STATE OF NORTH CAROLINA
DEPARTMENT OF TRANSPORTATION

SUBJECT: Pamlico County; NC 55 from SR 1127 (Bayleaf Road) to East of
SR 1129 (Bennett-Tingle Road); State Project No. 8.1170901;
T.I.P. # R-2539B

Widening of NC 55 From SR 1127 (Bayleaf Road) to East of SR 1129 (Bennett-Tingle Road) in Pamlico County Federal Aid Project No. STP-55(1) State Project No. 8.1170901

SUBJECT: R-2539B revised permit drawings and summary, sheets 19 and 39 of 40

SHEET 7 OF 40

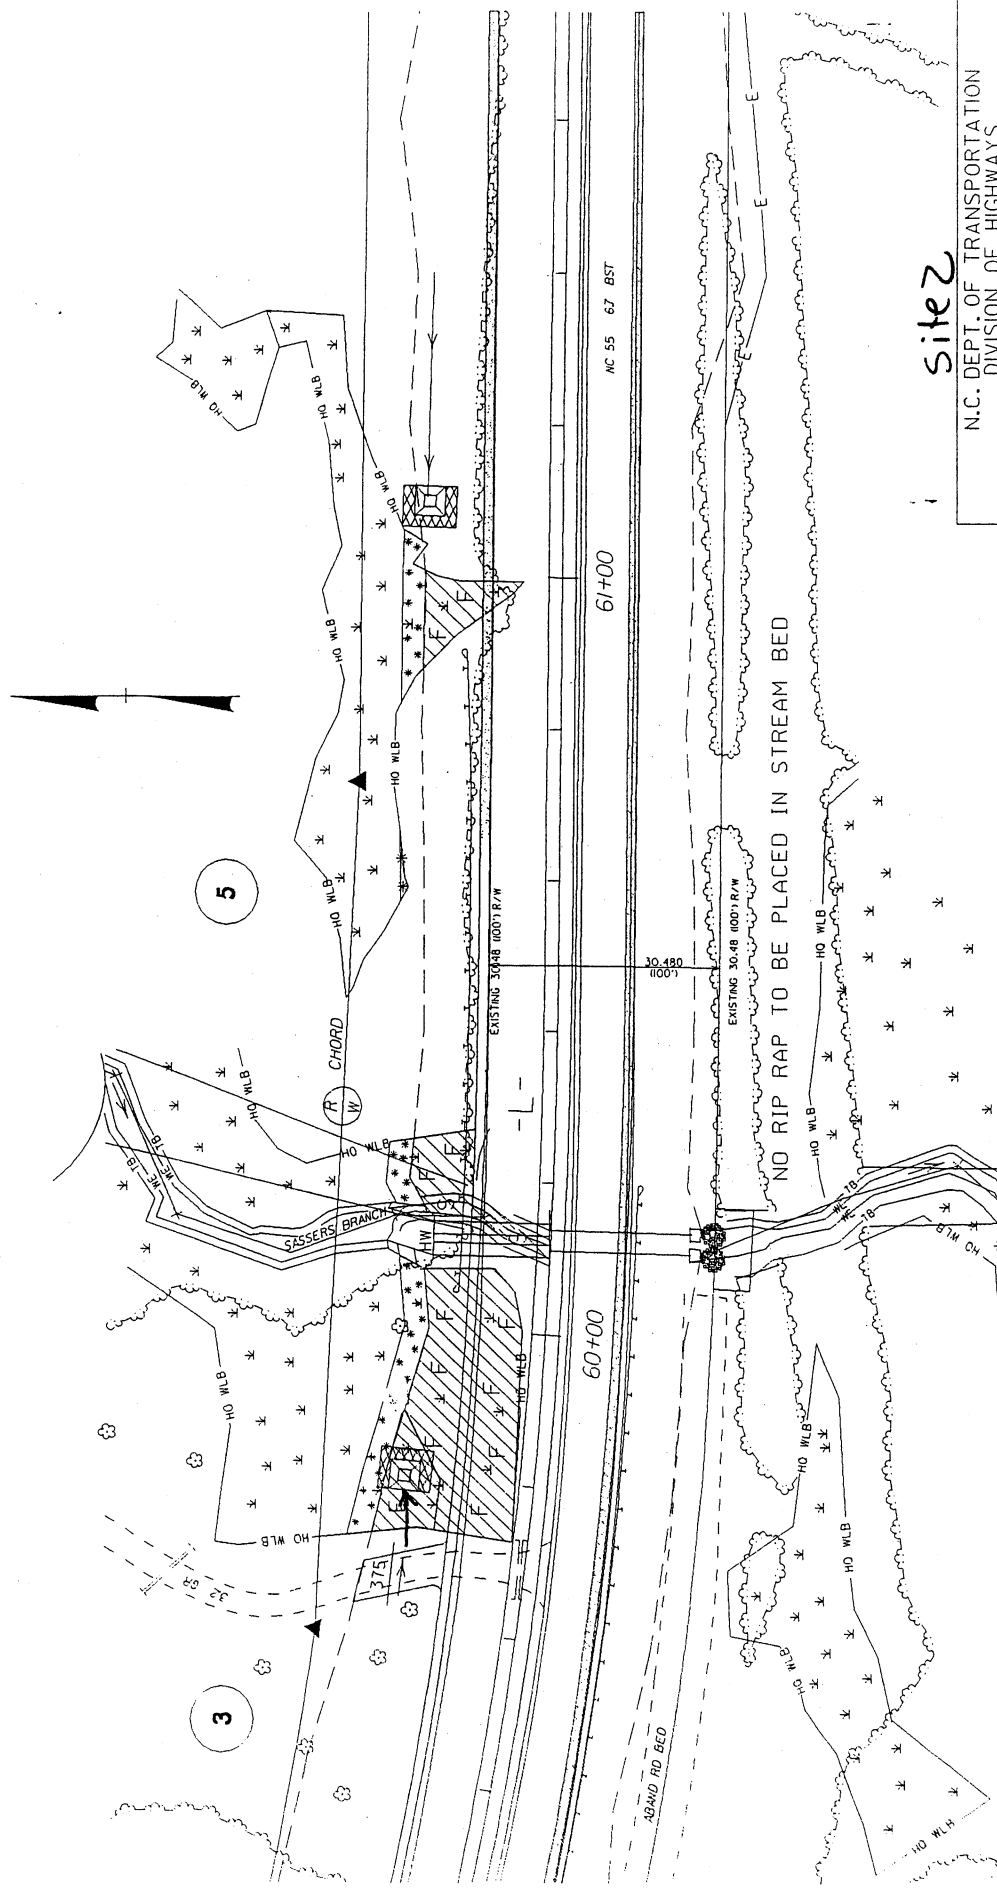
Site 1, Permit Sheet 7 of 40. Because of low grade and minimal drainage potential of the natural ground elevation at this site, NCDOT proposes to install a V-ditch with 6:1 side slopes to drain the subgrade of the new road. The new ditch will drain 0.06 acres of non-riverine wetlands.

SHEET 10 OF 40

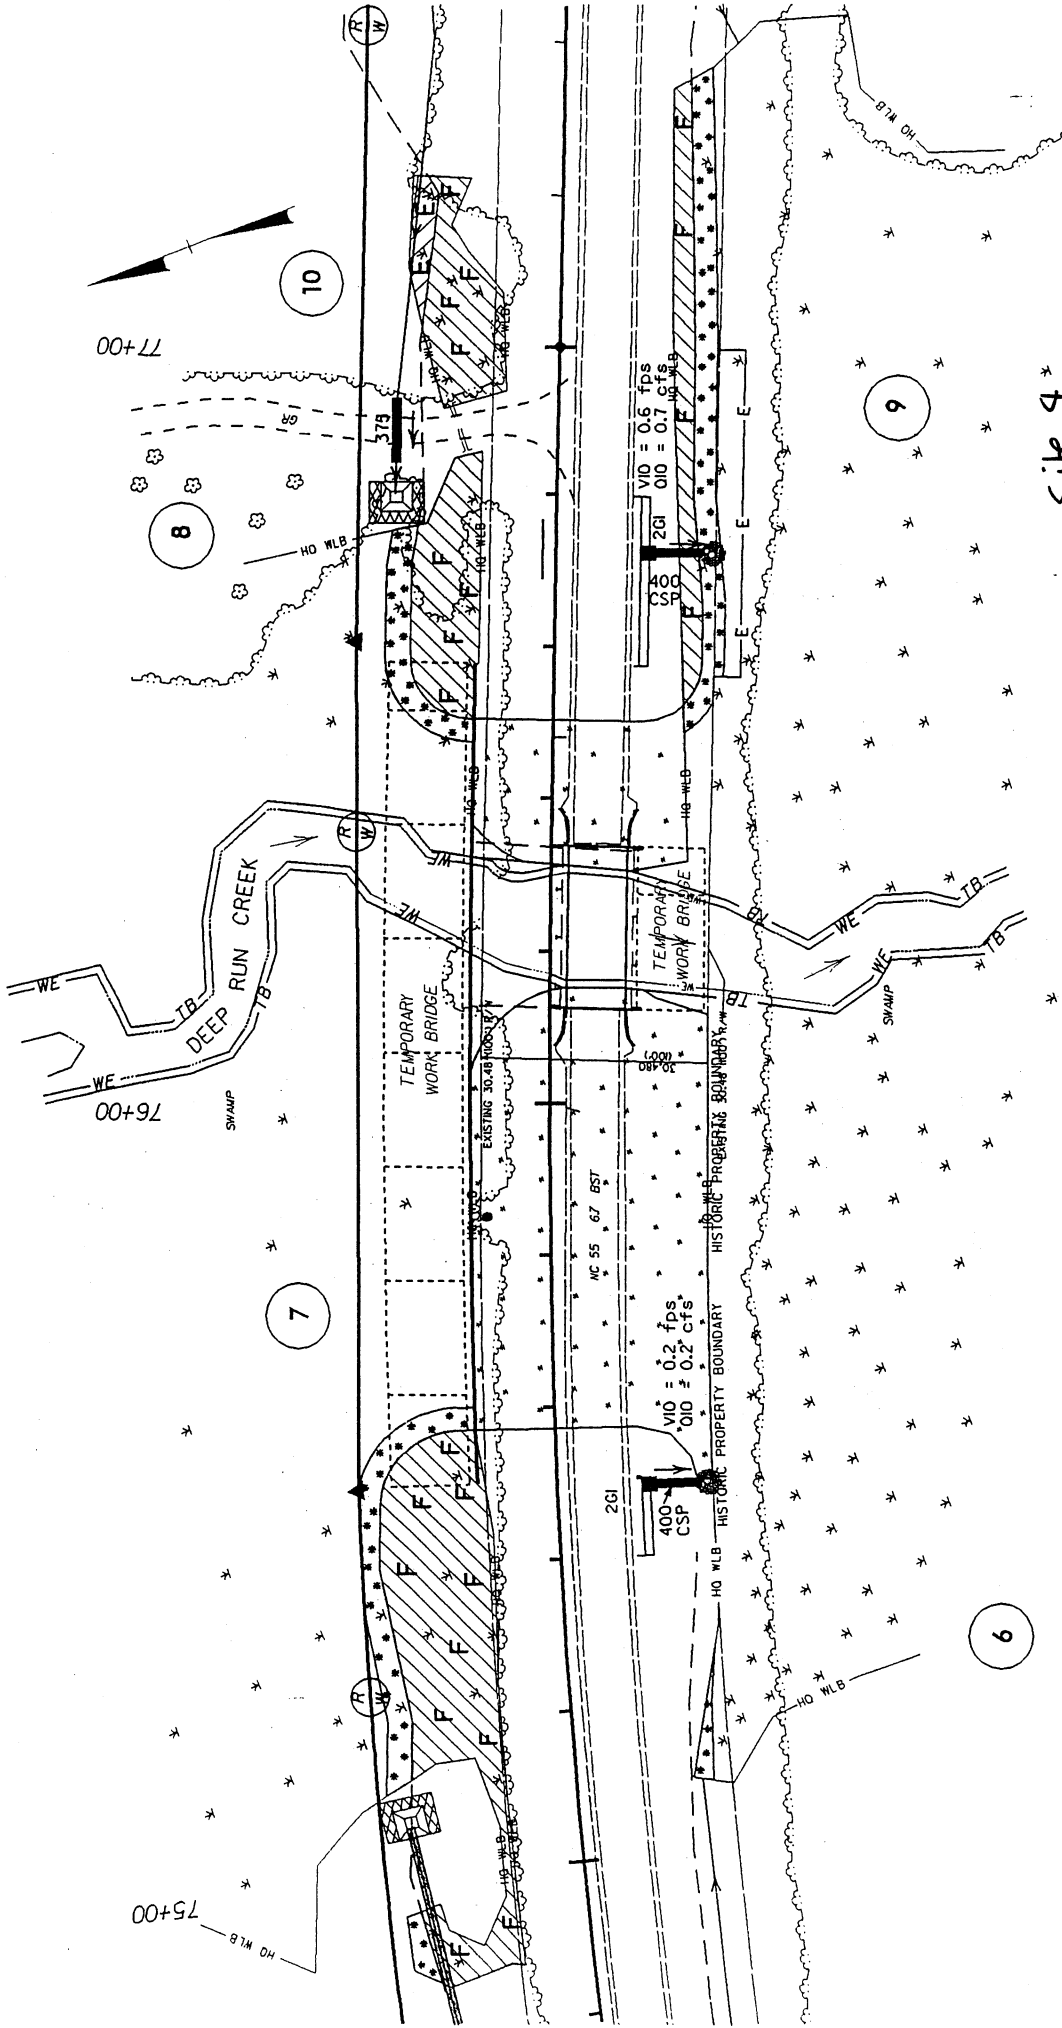
Site 4, Permit Sheet 10 of 40. At this site an area of mechanized clearing in wetlands has been changed to excavation to accommodate a drainage swale.
